# CITY OF ALBUQUERQUE

**Re: Gibson Shops**  
**1400 Gibson Blvd.**  
**Traffic Circulation Layout**  
**Architect's Stamp 8-15-17 (L15D049)**

GIBSON SHOPS  
TRAFFIC CIRCULATION LAYOUT  
1400 GIBSON BLVD  
ALBUQUERQUE, NM  
PROJECT # 1662

REVISION	DATE
RBA ARCHITECTURE, PC ARCHITECTURE PLANNING DESIGN 1400 GIBSON BLVD, SUITE 100 ALBUQUERQUE, NM 87102 www.rba1.com	
DATE	11-14-2017
SHEET NUMBER	TCL-1

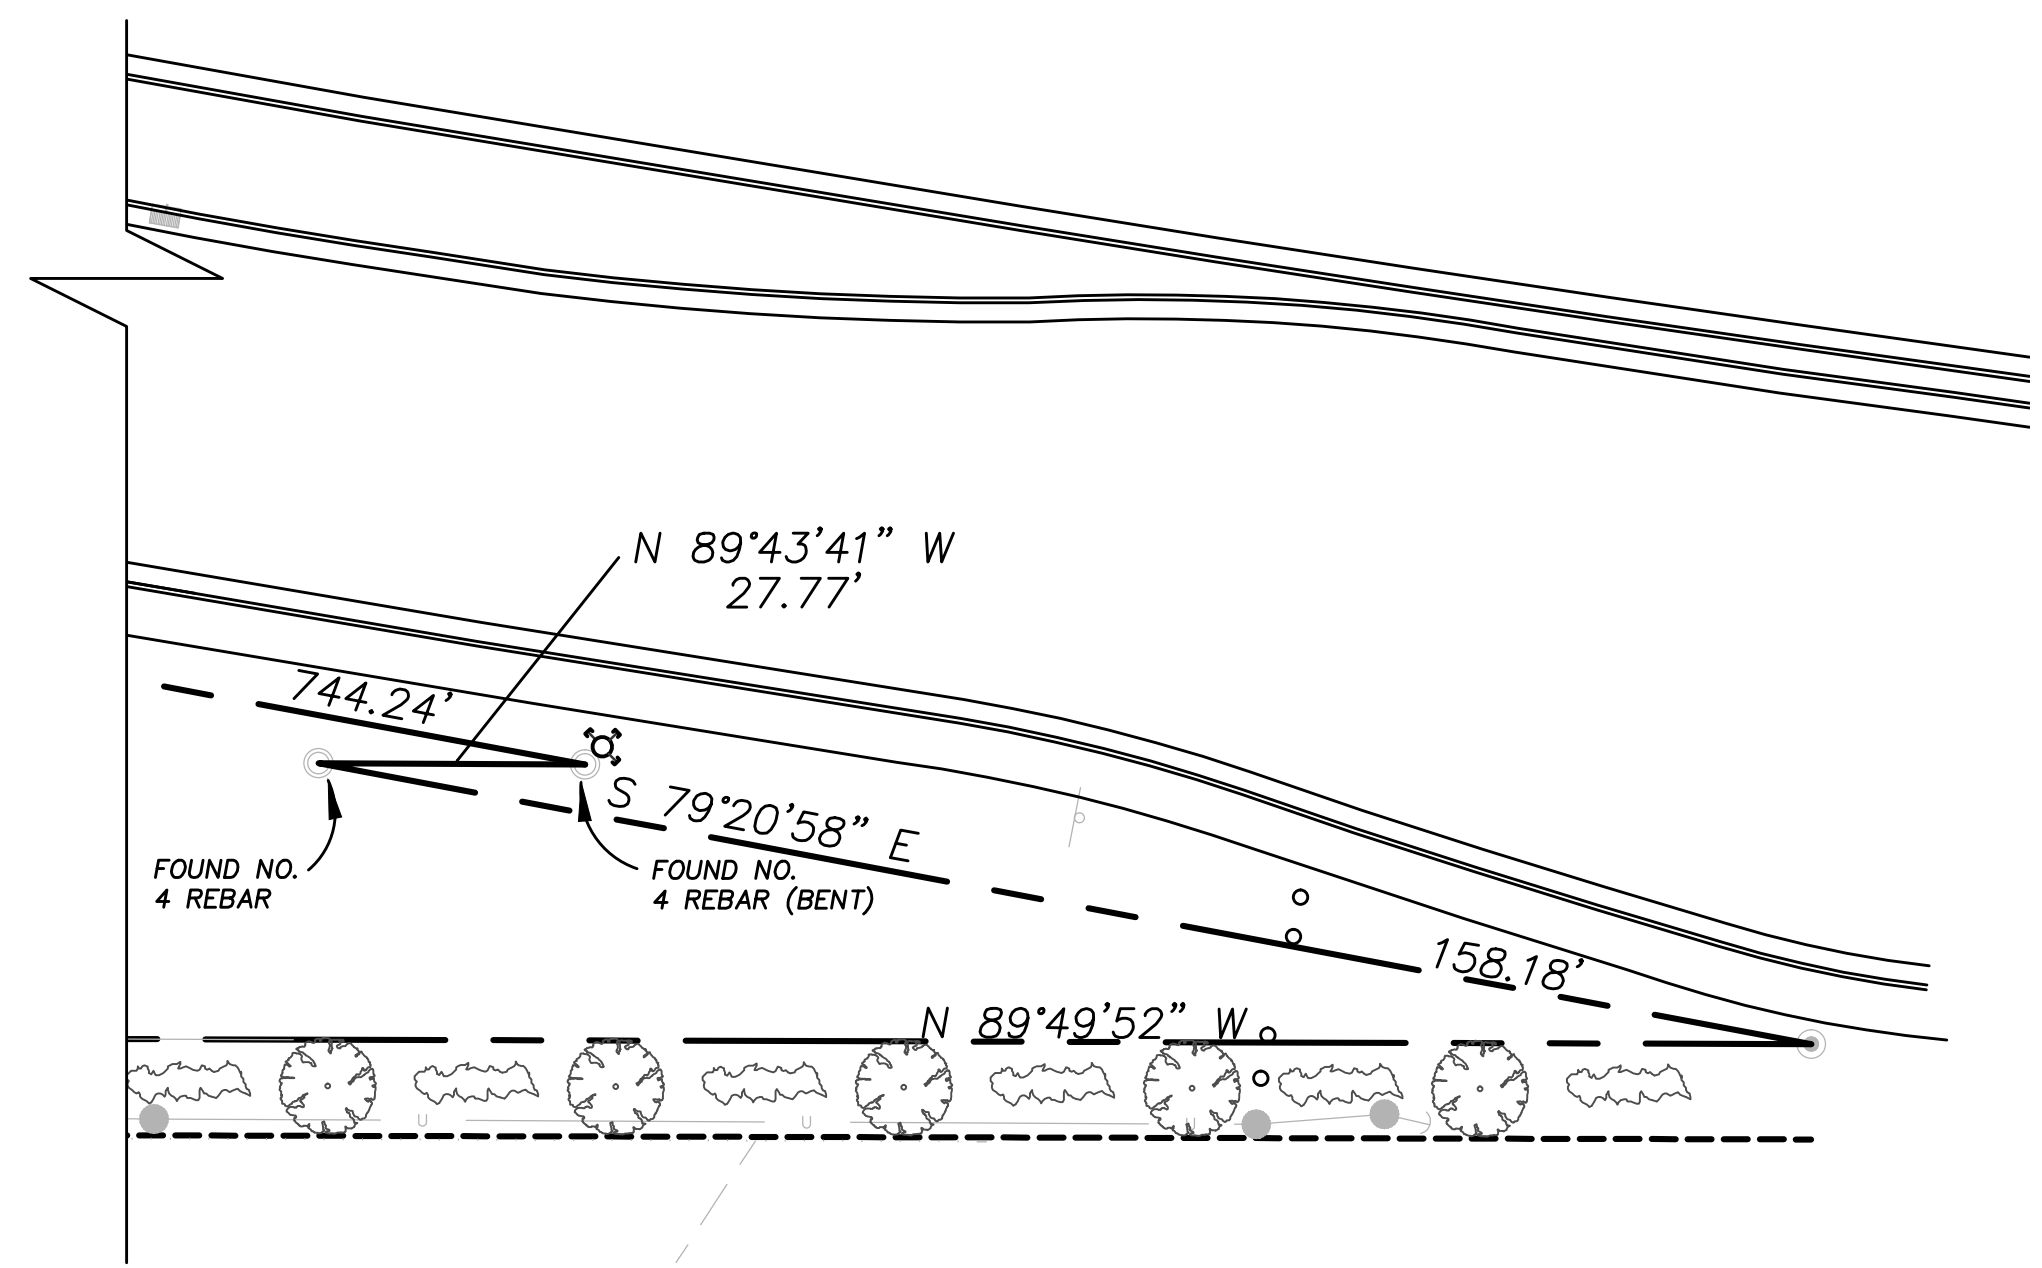
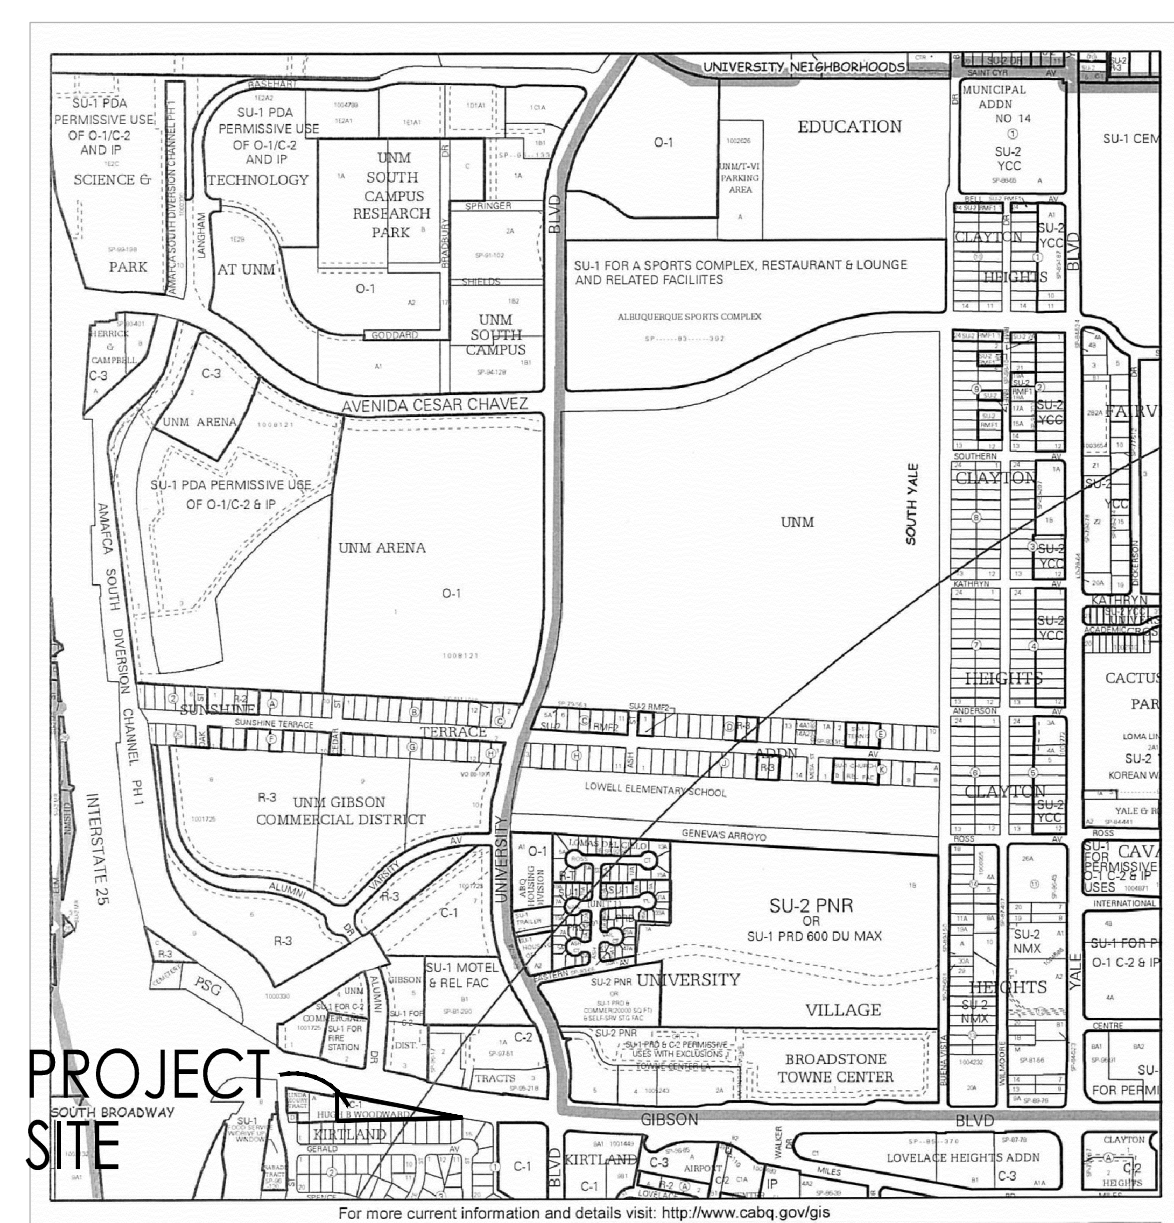
1. This site will need a phasing plan. The plan should show the improvements using the existing drive entrances to be able to open the Family Dollar.
2. City of Albuquerque cannot approve the TLC with the unapproved drive entrances shown as being constructed. They must have approval from the Road Access Committee RAC before they can be shown as new construction.

**FYI:** The TCL needs to show all the improvements and construction that will be complete for the final inspection to get the CO. If the TCL shows additional improvements connected to a later phase. Those improvements must be completed to pass the final inspection for the current building permit. We cannot approve this TCL with the current layout.
